Access Compliance Report

Public Rights-of-Way

(Curb Ramps)

| Intersection ID: 46812 | Main Street: ARBOR_VISTA_DR | Cross Street: ADLIN_AV | Location: | E |

| ADA ID: 43E0942141FA | Ramp Type: PerpDiag | Initial Pass/Fail: Fail | Overall Compliance: No | Severity Score: 22.5 |

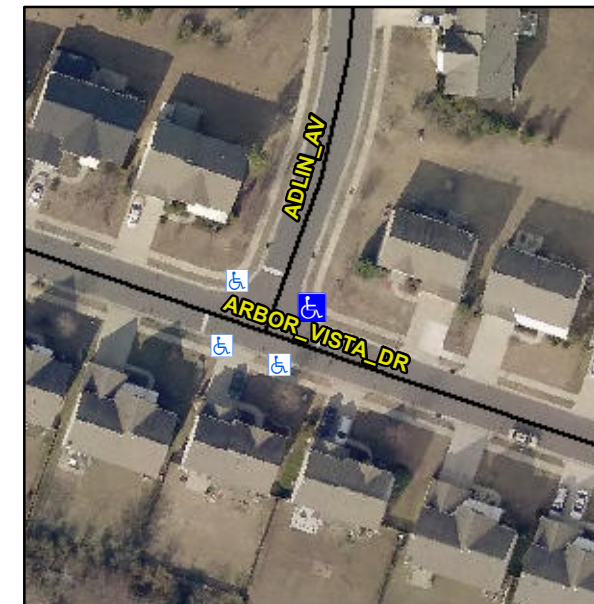
Not Found, R304.5.1, R304.2.2, R304.5.3

| Compliance | Description | Data | Compliance | Description | Data |
|------------|-----------------------|-------|------------|-----------------------------|-------|
| N/A | Ramp Length (in) | 47.0 | No | Ramp Slope (%) | 11.0 |
| No | Ramp Width (in) | 38.0 | No | Ramp XSlope (%) | 2.6 |

Remove & Replace Curb Ramp With Two New Directional Ramps or Equivalent.
